Agenda Item # 10

SUB-003211-2025

The Villas at Cody Crossing Subdivision

Proposal:

DETAIL SITE PLAN

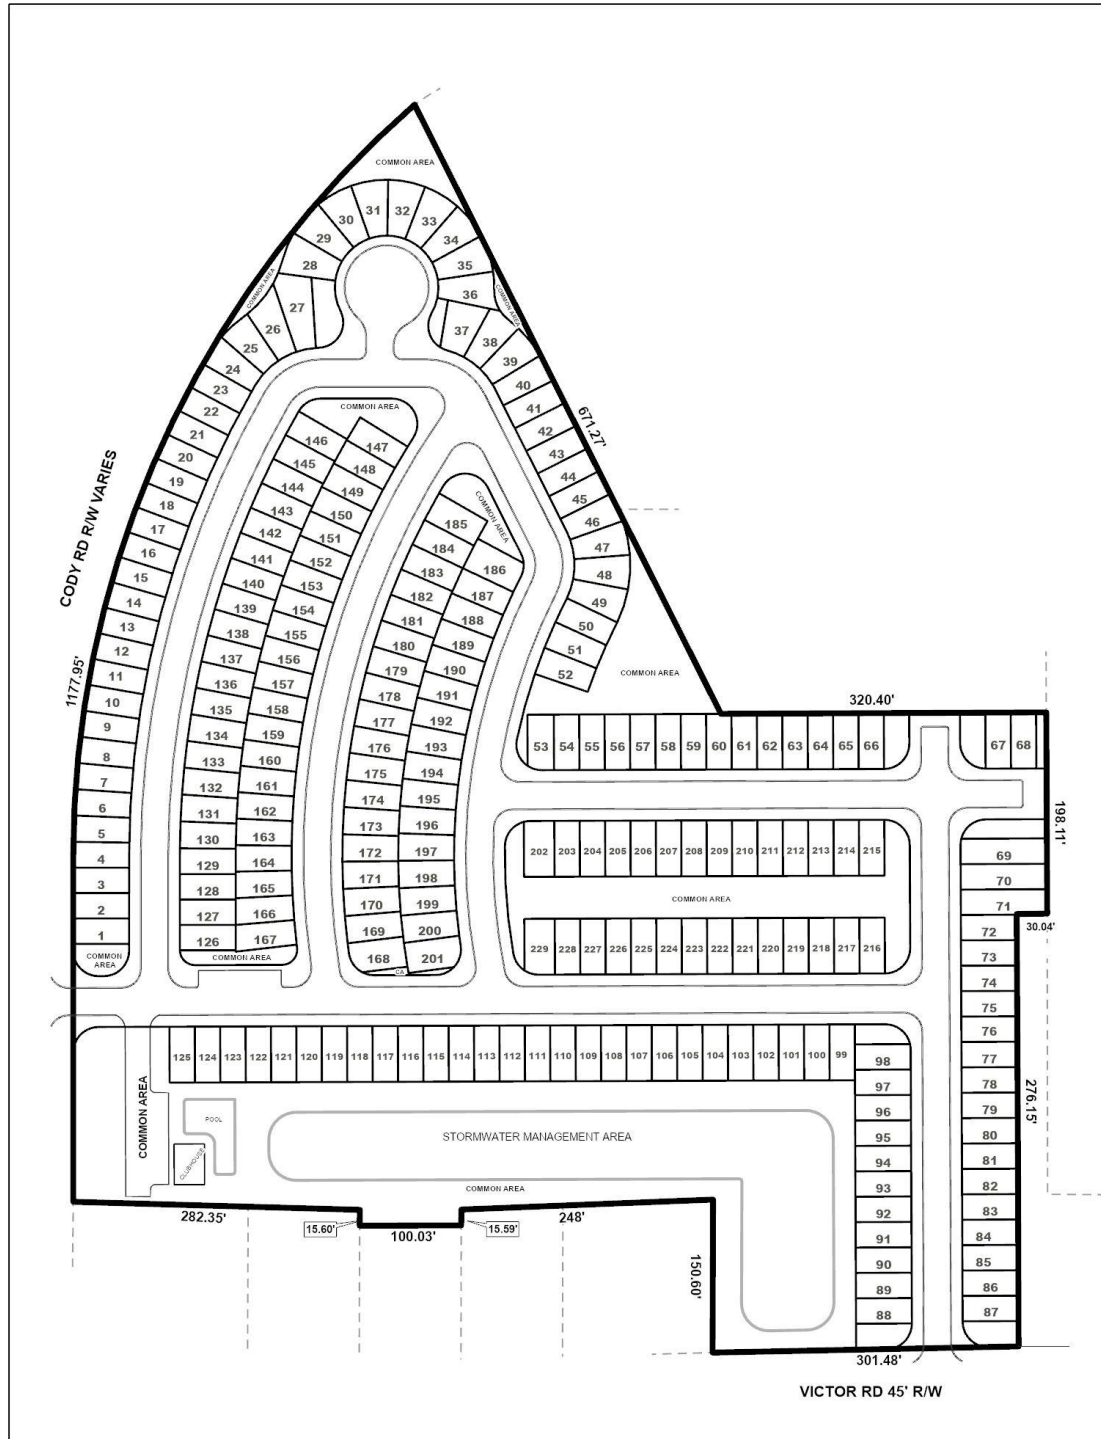
- D. Label the proposed ROW width(s).
- E. Label each separate Common Area with a unique designator (i.e. 1, 2). There appears to be 15 of them. Some of them are not labeled.

- F. No parking is allowed within the ROW.
- G. The cul-de-sac ROW radius is required to be 60'.
- H. Provide reference, on the map and the description, to a monumented corner.

- I. Provide and label the monument set or found at each subdivision corner.
- J. Provide an updated Plat for review after labeling the proposed centerlines and ROWs that will meet the current Subdivision Regulations.

The site has frontage along Cody Road North and Victor Road. Cody Road North is a Major Collector street without curb and gutter requiring a 100-foot right-of-way, and Victor Road is a minor street with a ribbon curb and gutter requiring a 50-foot right-of-way. The Preliminary Plat depicts a varying right-of-way along Cody Road North and a substandard, 45-foot right-of-way along Victor Road. As mentioned, Cody Road North requires a 100-foot right-of-way. Furthermore, rezoning of the property to R-3 required dedication sufficient to provide 50-feet from the centerline of Cody Road. As such, if approved, the plat should be revised to depict compliance with this requirement. Regarding Victor Road, if approved, the plat should be revised to illustrate dedication sufficient to provide 25-feet from its centerline.

Per Section 6.C.7. of the Subdivision Regulations, double frontage lots, such as the proposed Lots 1-24 and Lot 29, should be limited to one (1) street for access. As such, if approved a note should be placed on the Final Plat stating that Lots 1-24 and Lot 29 are denied direct access to Cody Road North.

Lot sizes range from 1,367 square feet to 2,179 square feet, which is incompatible with the minimum size requirement for lots served by public water and sanitary sewer in the R-3 suburban district. Per Article 2, Section 64-2-7.E. of the UDC, the minimum lot size for lots in the R-3 Suburban district is 10,000 square feet. As such, a waiver of Section 6.C.2.(a) of the Subdivision Regulations is required for approval of the request.

None of the lots meet the minimum 60-foot width requirement of Section 6.C.2(b)(2) of the Subdivision Regulations for residential lots located within the suburban sub-district. As such, a waiver of Section 6.C.2(b)(2) of the Subdivision Regulations will be required for approval of the request.

Seventeen (17) common areas are proposed. No information regarding each of their sizes is depicted, as required by Section 5.A.2(f). As such, if approved, each common area should be labeled with its size in both square feet and acres on the Final Plat; or provision of a table on the Final Plat with the same information will suffice.

A 10-foot front yard setback is requested on each proposed lot, which is incompatible with the minimum 25-foot front yard setback requirement of Article 2, Section 64-2-6.E. of the UDC for lots in the R-3 Suburban district. As

such, if approved, the Final Plat should be revised to illustrate a 25-foot front yard setback along each street frontage, unless a Variance allowing reduced setbacks is approved by the Board of Zoning Adjustment. It should be noted that, if approved, the development of each lot is subject to full compliance with the minimum standards of the UDC. This includes compliance with side and rear yard setbacks, site coverage, etc. The proposed development will not comply with these requirements without the approval of Variances from the Board of Zoning Adjustment.

1. Dedication to provide 50-feet from the from the centerline of Cody Road;
2. Dedication to provide 25-feet from the from the centerline of Victor Road;

9. Placement of a note on the Final Plat stating that Lots 1-24 and Lot 29 are denied direct access to Cody Road North;
10. Revision of the plat to label each lot with its size in square feet and acres, adjusted for dedication, or provision of a table on the Final Plat with the same information;

13. Revision of the plat to illustrate a 25-foot front yard setback along each proposed street, in compliance with Section 6.C.8. of the Subdivision Regulations, and with Article 2, Section 64-2-6.E. of the Unified Development Code, or acquisition of the necessary variances;
14. Compliance with all Engineering comments noted in this staff report;
15. Placement of a note on the Final Plat stating all Traffic Engineering comments noted in this staff report;
16. Compliance with all Urban Forestry comments noted in this staff report;
17. Compliance with all Fire Department comments noted in this staff report; and
18. Full compliance with all other codes and ordinances.
